SAFETY RECALL NOTICE

**SAFETY RECALL RVXX0902
DECEMBER 2010 – 2nd Notice**

RVXX0902, Wiper Motor Recall

Figure 1 — Valeo wiper motor

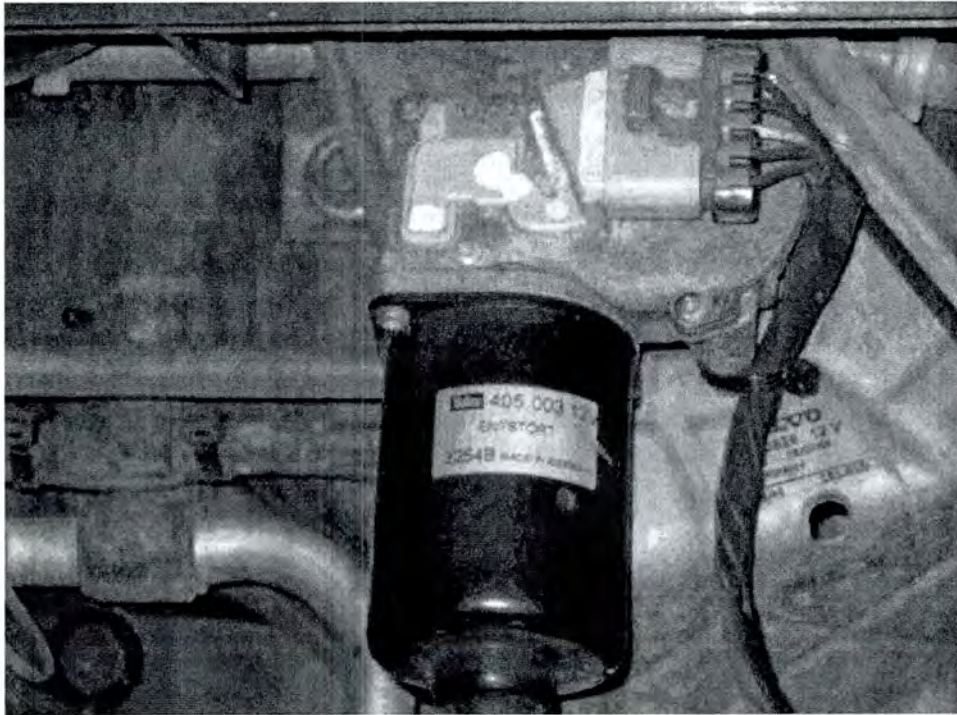
2. Verify that the vehicle has a Valeo wiper motor (figure 1). If the truck already has a Sprague wiper motor (figure 2) installed, file a claim for inspection time using the recall authorization making an appropriate note in the warranty claim.

Example of melted connector:
(Plastic melted and charred)

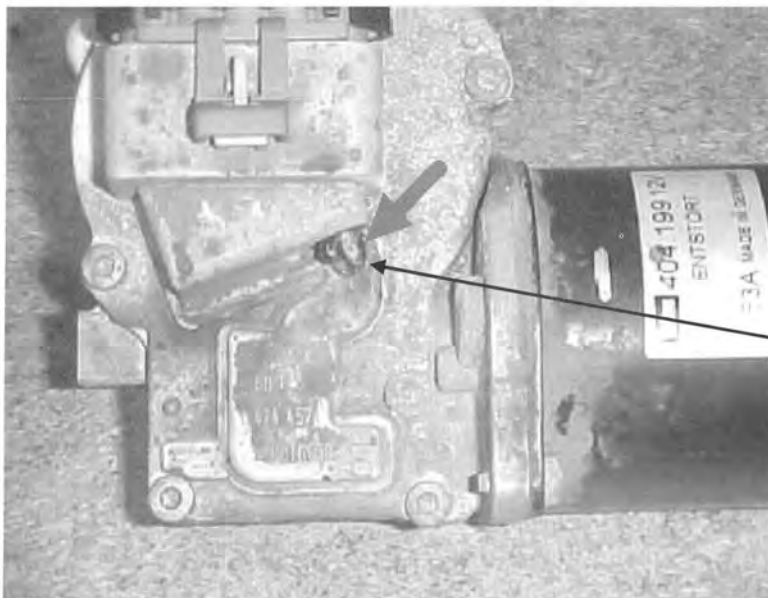
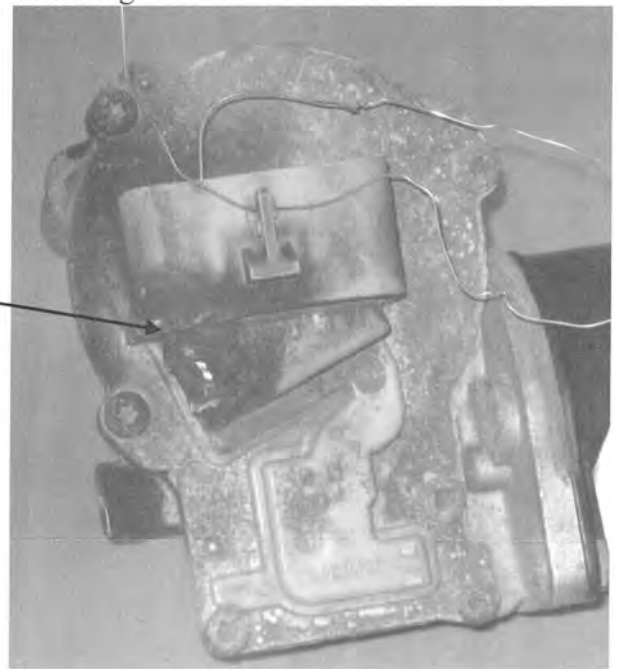
Volvo **strongly recommends** that you inspect the wiper motor for evidence of overheating (melting or charring) (see photos on the last page of this document in the section titled "Inspection") during your daily pre and post trip vehicle inspections.

The two images below show connectors that exhibit signs of overheating:

If your motor shows signs of overheating, do not drive the vehicle; also remove the ignition key. You should contact Volvo's wiper motor recall support line (1-877-800-4945) for further help and instruction.
